Memorandum

4 November 2019

To	Douglas Shire Council and Department of State Development, Manufacturing, Infrastructure and Planning		
From	Sarah Wilson - GHD	Tel	+61 7 5413 8133
Subject	Response to information request from Douglas Shire Council (DSC) and Department of State Development, Manufacturing, Infrastructure and Planning (DSDMIP) Wangetti Trail SP1 - Combined Development Application Response to request for information 1909-13127 SRA	Job no.	4132458

Figure 3 Locality SP1

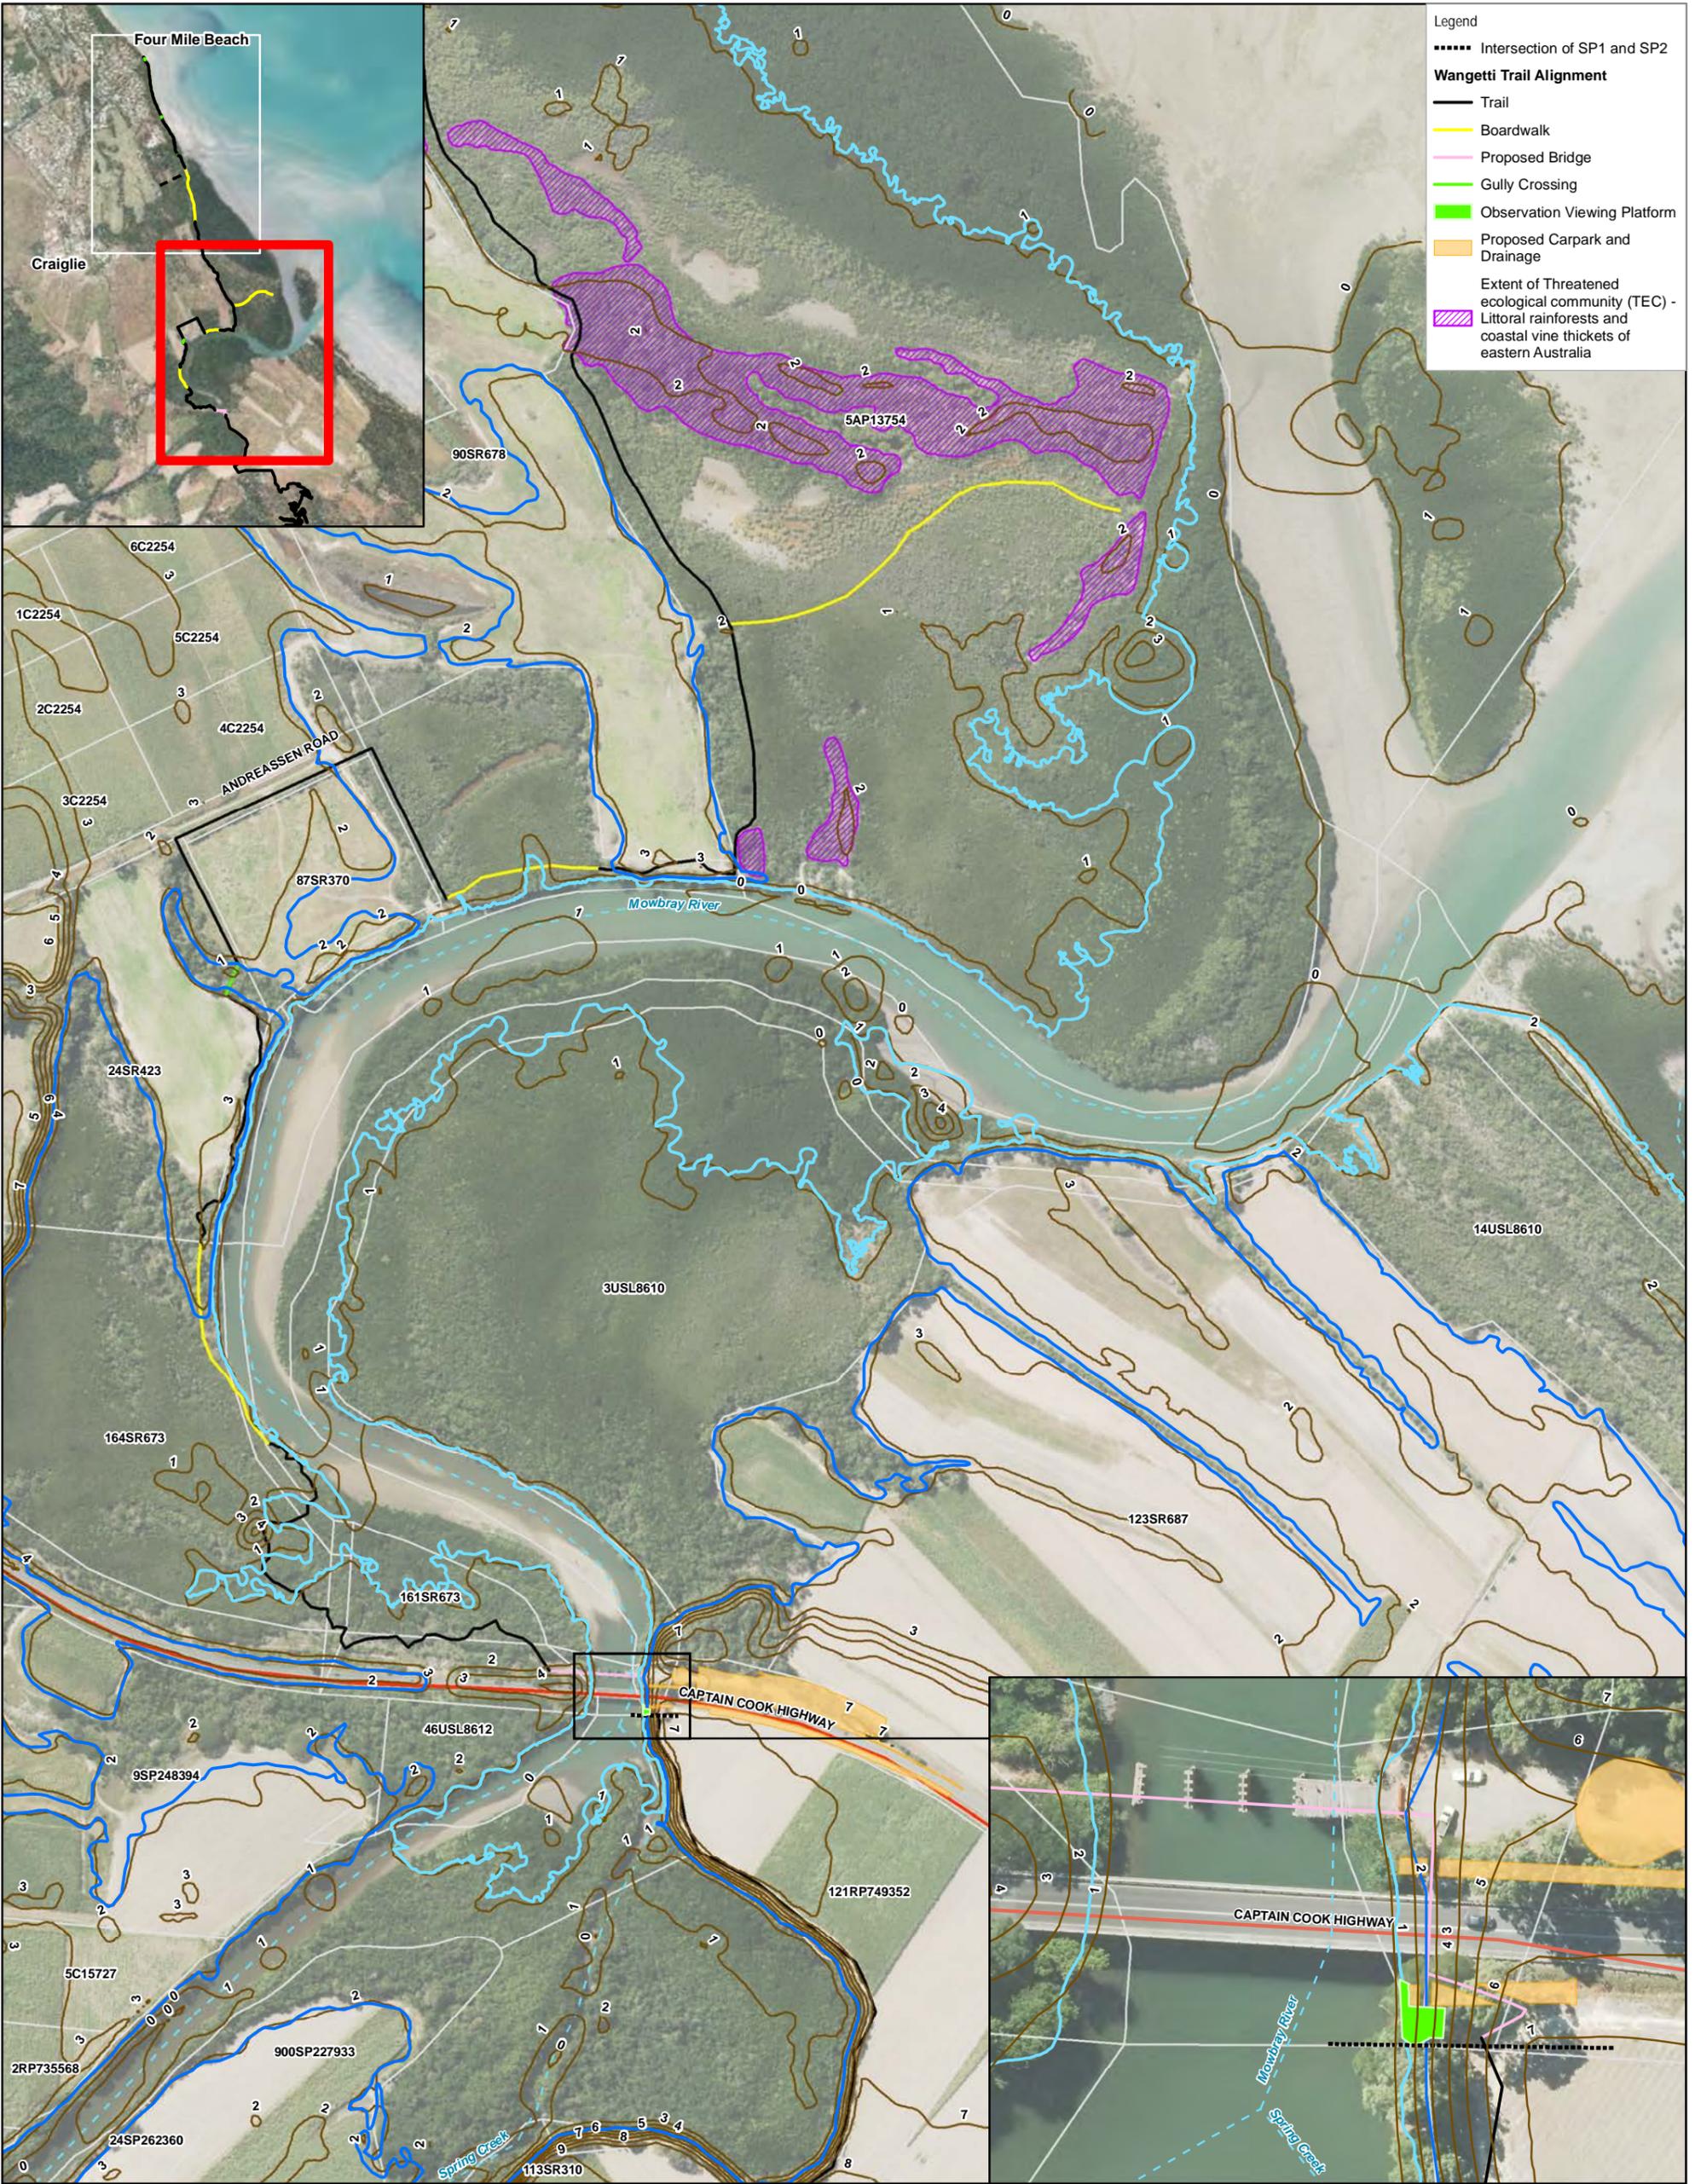
Item 2 (f) Provide information of the existing tidal land levels (i.e. contour lines)

- I. Identify all locations where crushed rock will be used to construct the track and any creek crossings where rocks are proposed.*
- II. Provide detailed information of the existing tidal land levels (i.e. contour lines).*
- III. Discuss the natural tidal inundation levels of tidal land and connectivity of all adjacent habitat under elevated flow events.*
- IV. Provide details of the hard trail construction including elevations.*

Figure 3 shows the location of the proposed works for Wangetti Trail SP1 as well as the following additional information:

Refer to the response provided to Item 2 (f) in Section 2.1 and refer Figure 3, which identifies the location of the Wangetti Trail SP1, the existing tidal land levels and contour lines.
